DOE/EA – 1492

**ENVIRONMENTAL ASSESSMENT
COMMENT RESPONSE, AND
FINDING OF NO SIGNIFICANT IMPACT**

Pond and Land Configuration

U.S. Department of Energy
Rocky Flats Project Office
Golden, Colorado

Figure 1-4. Rocky Flats Environmental Technology Site 100 Year Floodplain

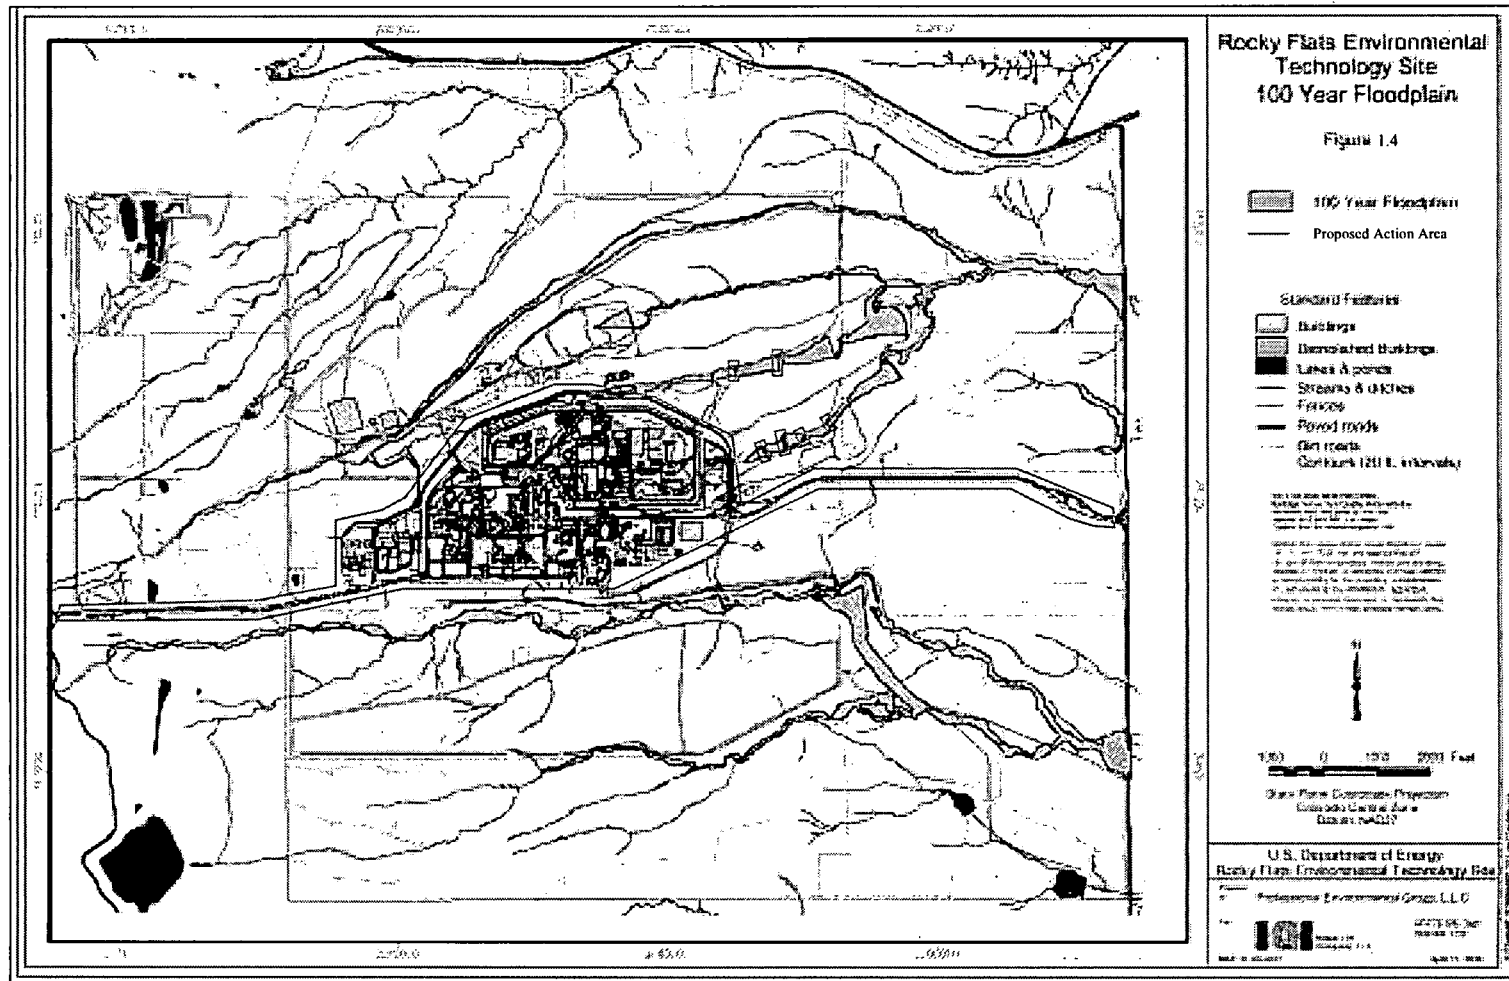
22.	There is a 100-year flood plain map on Page 8 of the document. The Board requests the Site provide the date of the map.	22	The date of the map in Figure 4-1 is included and is April 13, 2004.

Figure 2-2. Typical Front View of Modified Dam

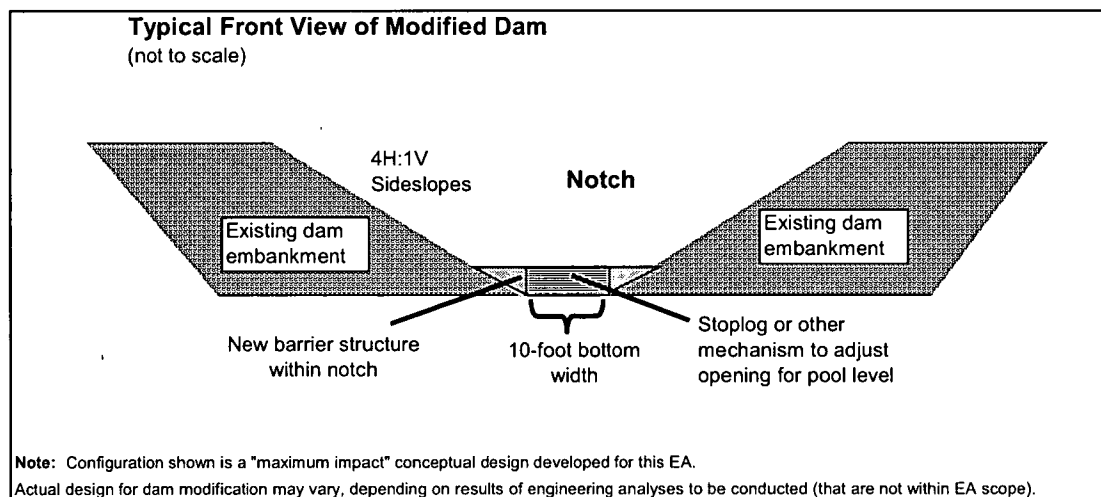
18.	The draft proposed action alternative states a <i>“notch” will be cut into each dam to reduce its effective height (Figure 2-2), thus creating a lower-profile.</i> Provide Broomfield with the process to disposition the removed soil from the dam and the characterization plan for the media.	17	Please refer to Responses to Groups of Similar Comments – Waste Characterization and Disposal.

Comment Number	Comment	Response Category	Response
22.	The draft proposed action alternative states a <i>“notch” will be cut into each dam to reduce its effective height (Figure 2-2), thus creating a lower-profile.</i> We understand the design is conceptual at this stage and the invert elevation of the notch would be the same as the pond bottom elevation. We also understand the actual design for the dam modifications may vary, depending on the results of engineering analysis. The EA states the engineering analysis is not within the scope of the EA, yet it is a crucial aspect of the proposal. Provide Broomfield with the objectives for the engineering analyses. Also identify the document that will contain the engineering analysis.	10, 24	Please refer to Responses to Groups of Similar Comments – Exclusion of Detailed Infrastructure and Operations.
